ENCLOSURE

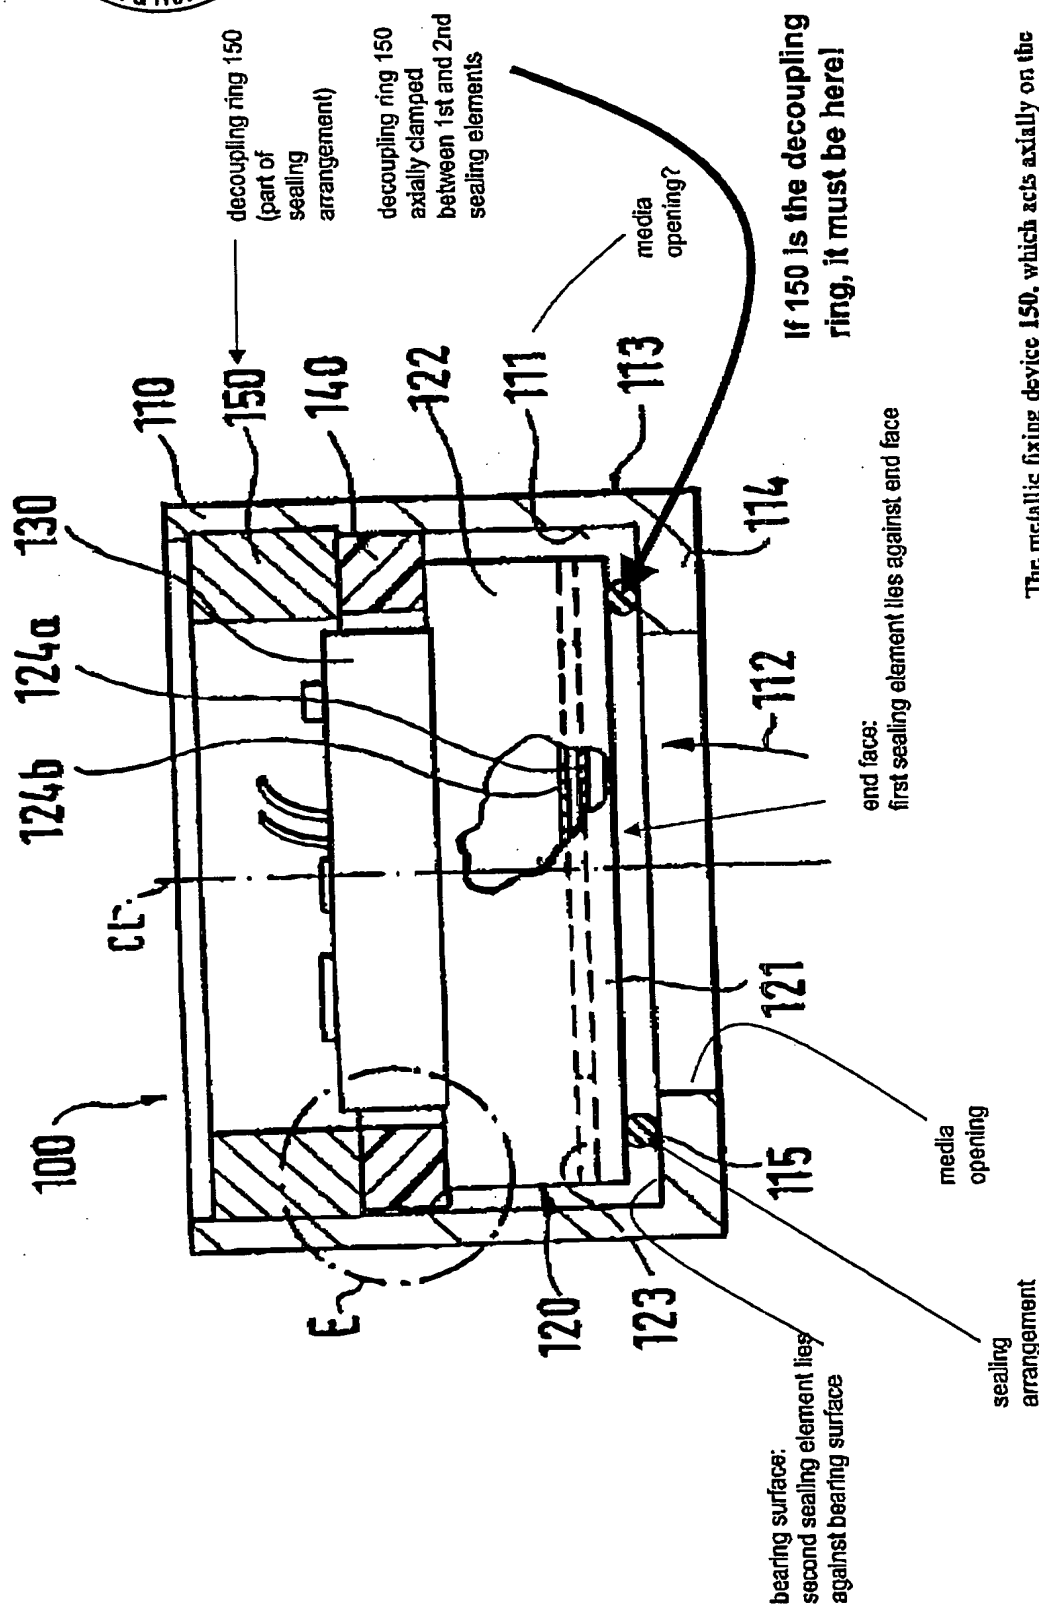
**If 150 is the decoupling ring, it must be here!**

According to the Examiner, this means that the sealing arrangement comprises first and second ring-shaped sealing elements and a decoupling ring (150)
